Docket No. 50-346

This is in response to your letter dated March 8, 1982 (Log No. 918) concerning Masonry Wall Design; IE Bulletin 80-11, Request for Additional Information as it relates to Davis-Besse Nuclear Power Station Unit 1.

RESPONSE TO NRC QUESTIONS  
MASONRY WALL DESIGN

IDEALIZED SIMPLY-SUPPORTED UNIFORM BEAM

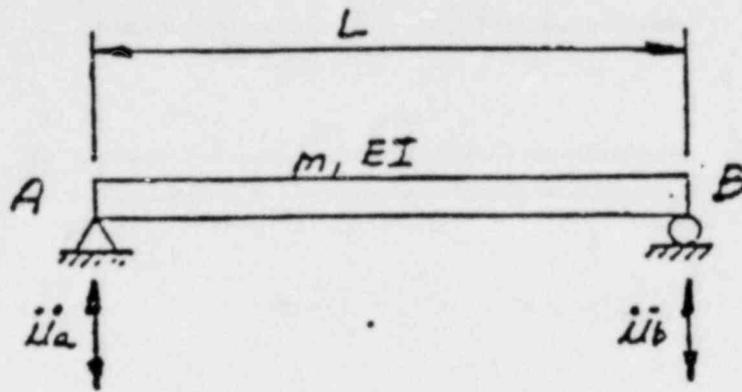
With reference to Section 7.1, Appendix E (2), use the envelope of the floor spectra or provide justification for using the average spectral acceleration.

The evaluations herein demonstrate that the use of the average floor acceleration response spectra to calculate the response of the wall panel is appropriate.

For the purposes of this evaluation, the seismic response of a simply-supported, uniform beam simulating a strip of the wall panel with unit width is considered, as shown in Figure 1:
